**EPA Superfund  
Record of Decision Amendment:**

**Allied Chemical & Ironton Coke  
Ironton, OH  
9/30/1998**

**RECORD OF DECISION AMENDMENT #3  
ALLIED CHEMICAL/IRONTON COKE SUPERFUND SITE  
Ironton, Ohio**

DRAWN BY	GSJ	CHECKED BY	DJS	11-12-97	DRAWING NUMBER	313234-A110
	11-12-97	APPROVED BY

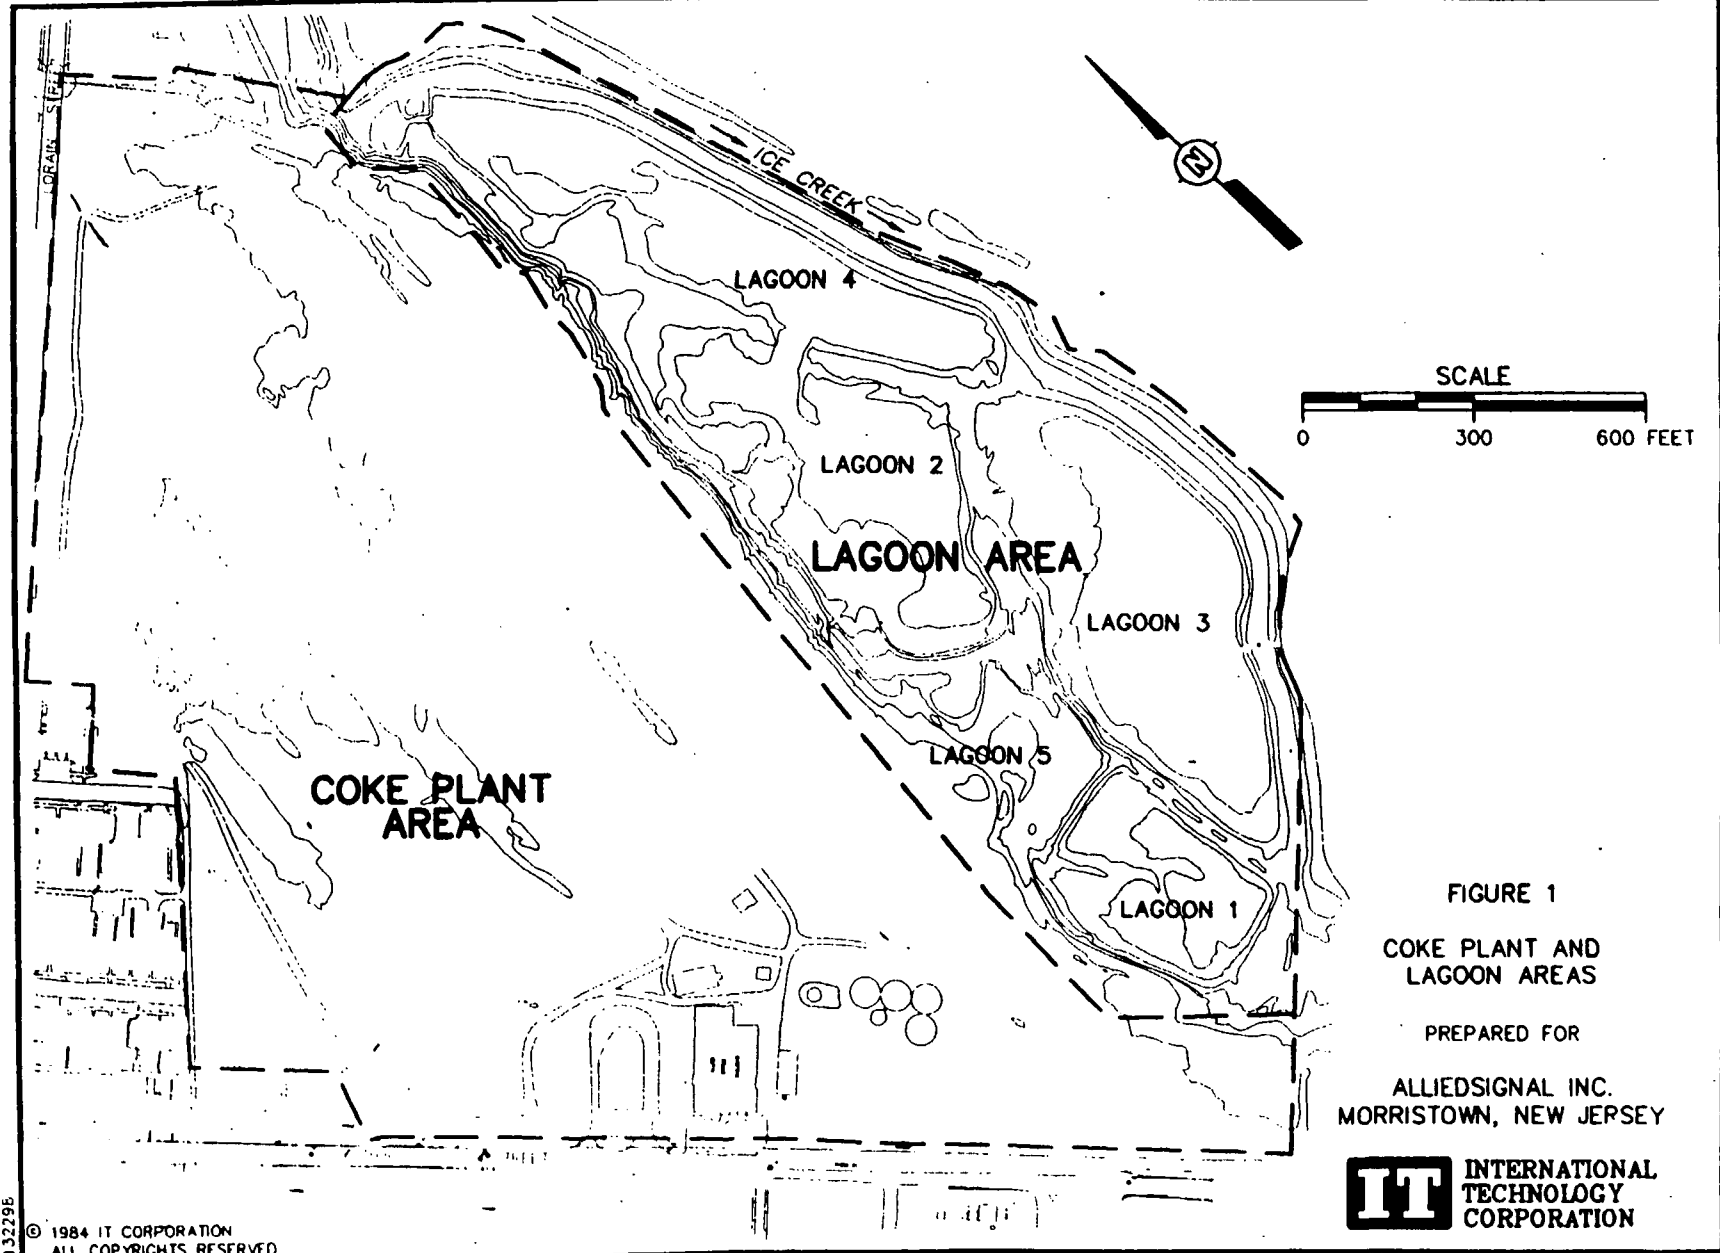
Therefore, U.S. EPA is clarifying the remedy selected in ROD Amendment #3 to off-site recycling of the "clean" soft tar at the Acme facility. Hard tar will be treated off-site at the Baldwin facility. Coal/coke fines will be used as an alternative fuel. The remaining material including large debris commingled with KO87 waste and "dirty" soft tar which fails to meet the specifications for recycling will be disposed off-site in compliance with State and Federal hazardous waste regulations. It is currently anticipated that this last category of material would be sent to a facility operated by Laidlaw Corporation in Corunna, Canada. As part of the off-site disposal at the Canadian facility, following stockpiling of the material, samples will be collected for analytical testing for parameters required by the disposal facility. These tests will be performed to determine a 15 psi penetration. This is a compressibility standard established by the facility to aid in material placement options. It may become necessary to stabilize the material to meet the compressibility standard and because at different times during the removal of the soft tar handling the material may be difficult due to warm weather and fluidity of the tar. Cement or fly ash will be added as a stabilizing agent. The stabilization will generally be performed in the lagoon area; however, it may become necessary to perform the mixing process in vessels near where the soft tar material will be stockpiled for shipment.

This modification in the selected remedy will not fundamentally alter the selected remedy with respect to scope, performance or cost. The same amount of soft tar, hard tar, and coal/coke fines will be removed from Lagoon 5 and managed off-site. Lagoon 5 will still be excavated, some soft tar will be recycled, the hard tar will still be treated, coal/coke fines will still be used as an alternative fuel, and uncontaminated debris will still be used either in cement kilns or placed back on-site into the excavated Lagoon 5, as approved in ROD Amendment #3.
